## *REMARKS*

# Annotated Marked-up Drawings

FIG. 1

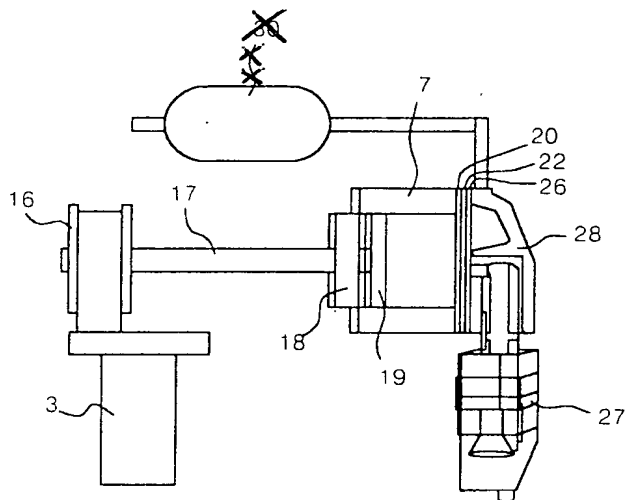
The Examiner has objected to the drawings, stating that Figs. 1 and 2A-2D should be labeled with a legend such as --PRIOR ART--.

not approved  
10/17/03

In order to overcome this objection, Applicants are concurrently submitting Replacement Sheets of drawings for the Examiner's approval, which include the label "Related Art". Applicants submit that the label "Related Art" meets the criteria of MPEP § 608.02(g) and is sufficient to distinguish Applicants' invention from that which is not Applicants' invention. Additional changes have been made to place the drawings in better form. Accordingly, reconsideration and withdrawal of this objection are respectfully requested.

FIG. 2A

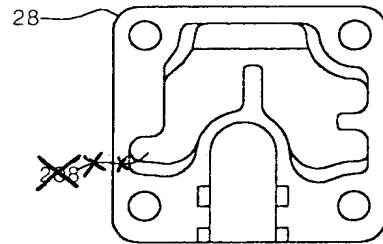
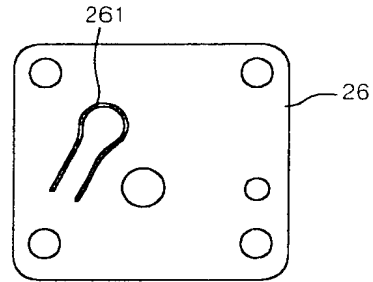
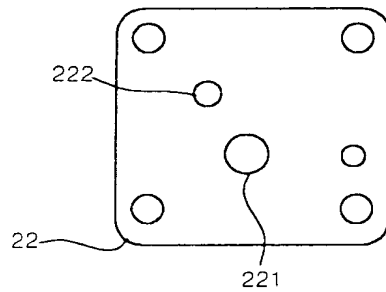
not approved  
RK  
10/17/03
